COMMUNITY DEVELOPMENT DEPARTMENT REPORT

SUBJECT: SHP-2024-0004
Modena Plaza Subdivisions

LOCATION: 3147 W. Belltower Drive, Lot 3 Block 6 of the Bridgetower Crossing Subdivision No. 2, located in the SW ¼ NW ¼, Section 35, Township 4N, Range 1W, Parcel # R1079860301

D. Short Plat (date: 3/6/2023)

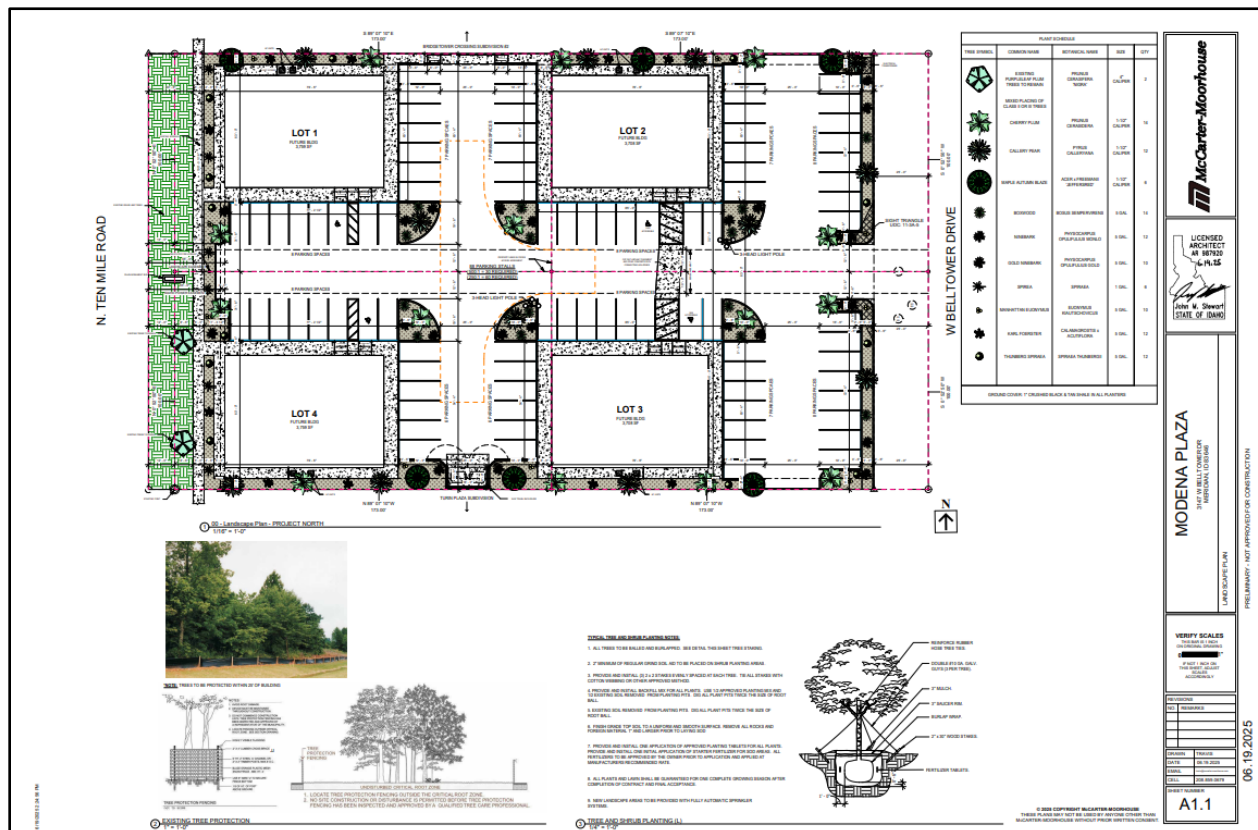
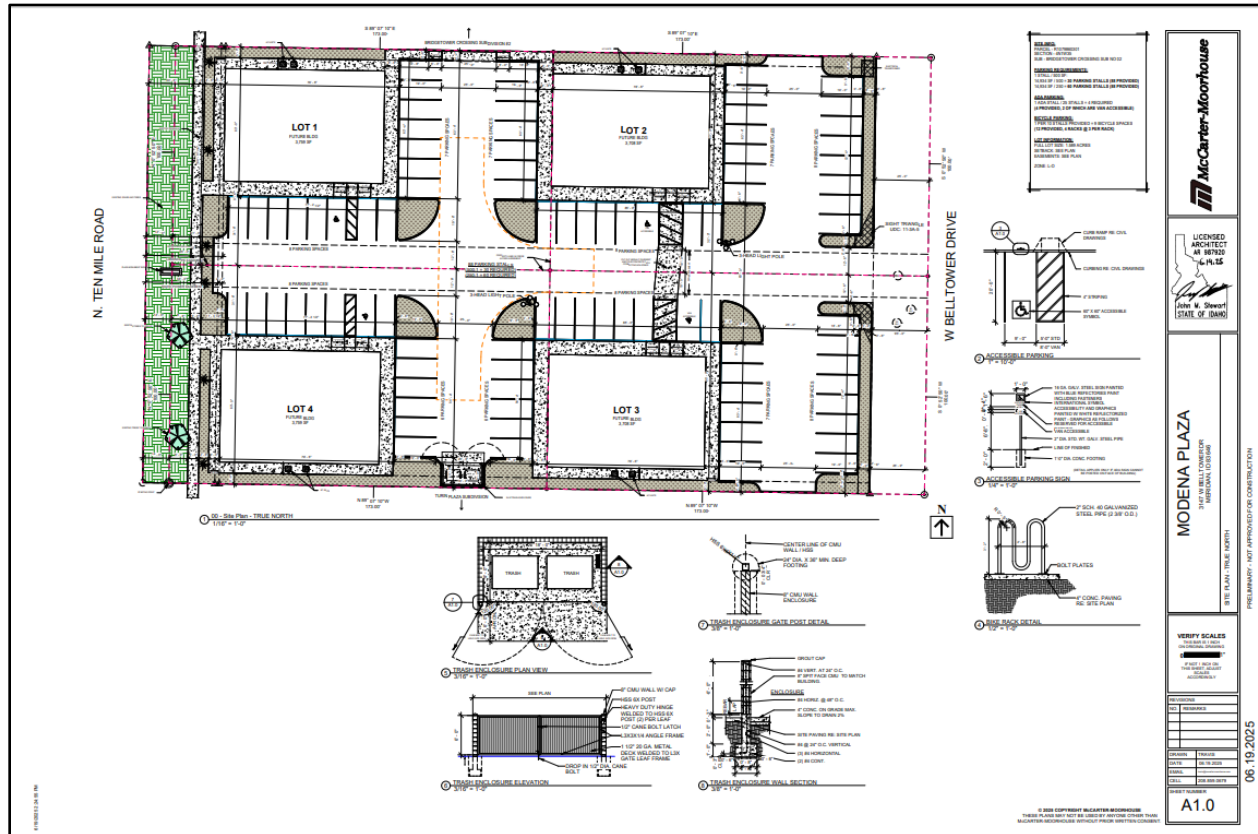
3. The short plat shall include the following revisions:
 - a. Include a note stating all lots within the proposed subdivision are subject to a cross-access/cross-parking easement.

- b. Note #8, add the instrument number for the cross access/cross parking easement.
 - c. Note #9, add the instrument number for the sanitary sewer and water easement.

- d. Provide and show easements/public right-of-way for all the sewer mains that the City will be operating and maintaining.
 - e. Add a note to the plat and show the front and rear ten (10) foot as well as the interior five (5) foot public utilities, irrigation and lot drainage easements for all lots.
